ECN/PCN No.: M1480

Product Description: RJ45, Single Port, Tab Up, SMD, 1000 Base-T	Abracon Part Number / Part Series: ARJ-102S	<input type="checkbox"/> Documentation only <input type="checkbox"/> Series <input checked="" type="checkbox"/> ECN <input checked="" type="checkbox"/> Part Number(s) <input type="checkbox"/> EOL
Affected Revision: Initial rev	New Revision: A	Application: <input type="checkbox"/> Safety <input checked="" type="checkbox"/> Non-Safety

Prior to Change:

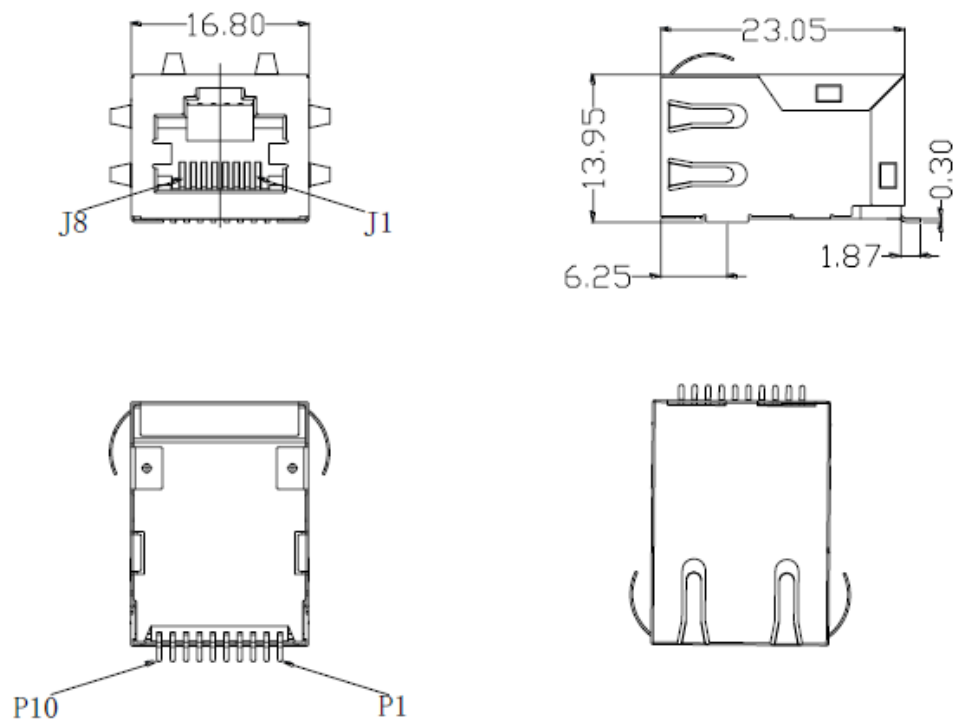
New material supplier and update to dimensions.

The changes described may affect the products form and fit. Abracon recommends careful review of the dimensional changes of package outline and footprint/layout.
